**ADDENDUM
NO. 2**

**FLINT LAKE ELEMENTARY SCHOOL AIR HANDLING UNITS
REPLACEMENT AND RELATED WORK
Valparaiso, IN 46385**

ADDENDUM TWO

Addendum Two (AD.02) to the drawings and specifications prepared by Gibraltar Design and The Skillman Corporation for **Flint Lake ES School Air Handling Units Replacement and Related Work** for Valparaiso School Corporation, Valparaiso, Indiana.

DRAWING
**UNIT "B" ELECTRICAL
FIRST FLOOR POWER PLAN**

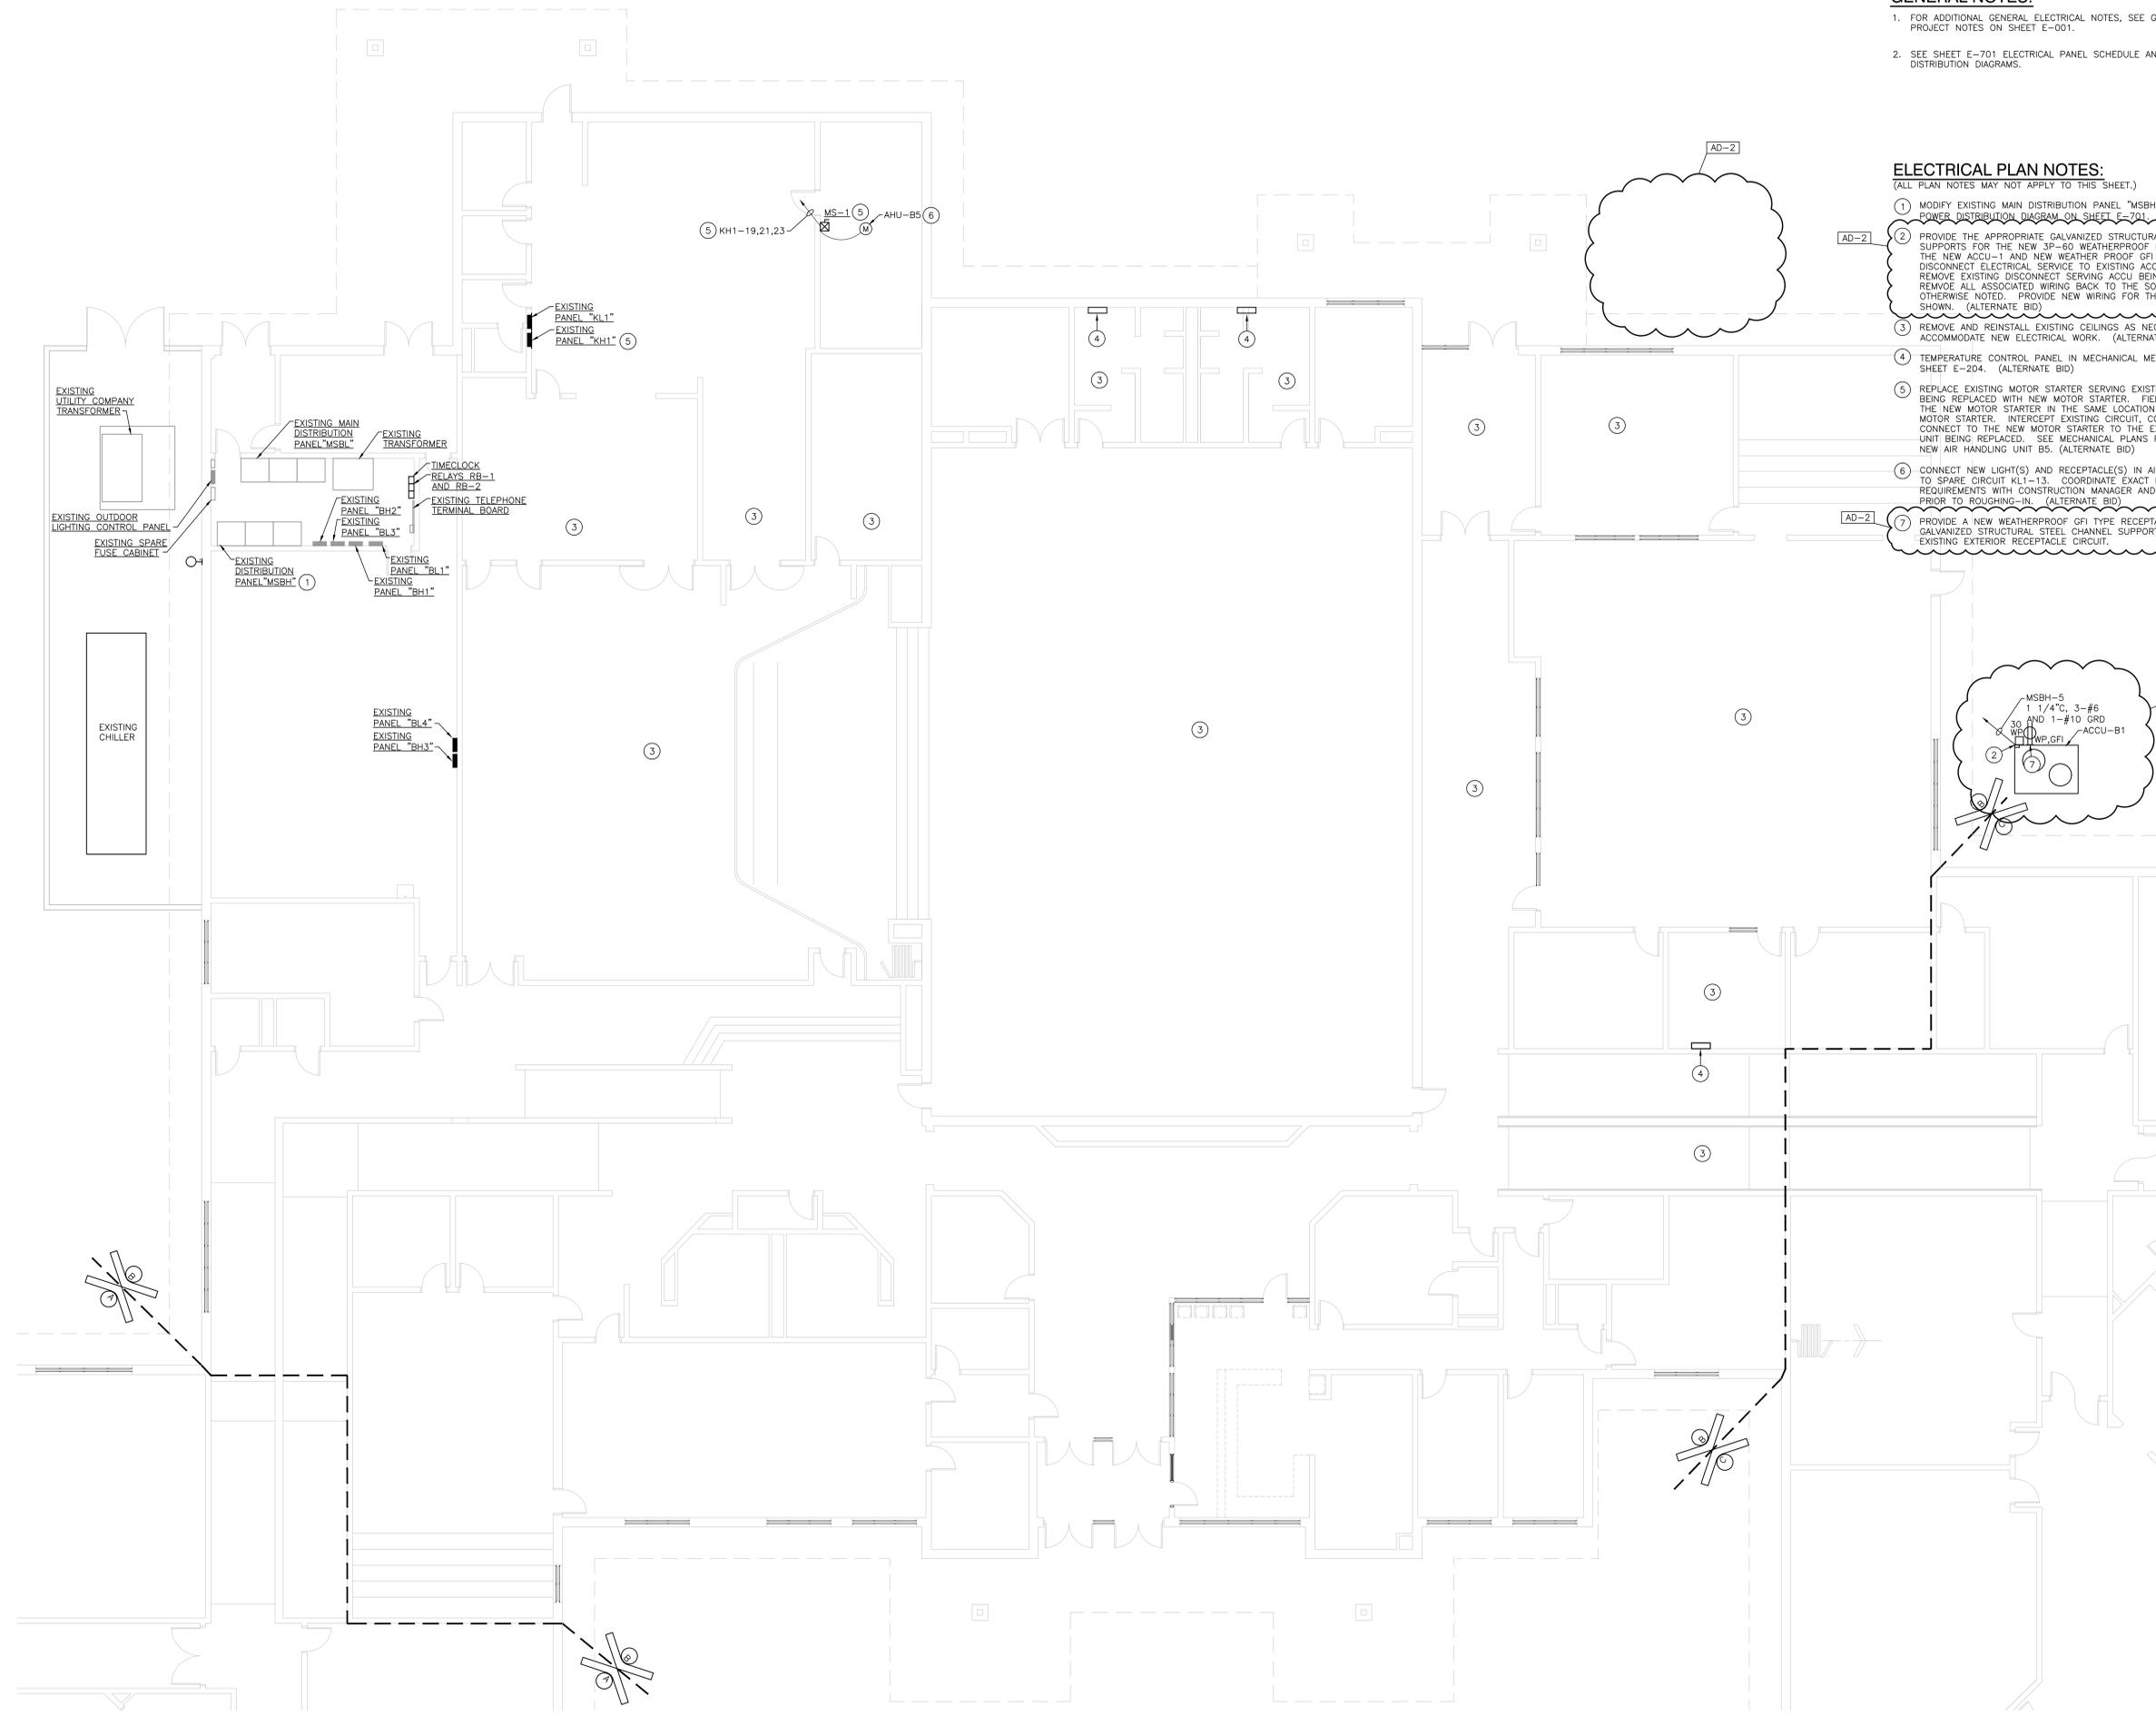
2. **Sheets E-202**

- A. The revised location for the new Condenser Units to be located at the location of the existing Condenser Units is updated and impacted the electrical design – please refer to the attached drawing.
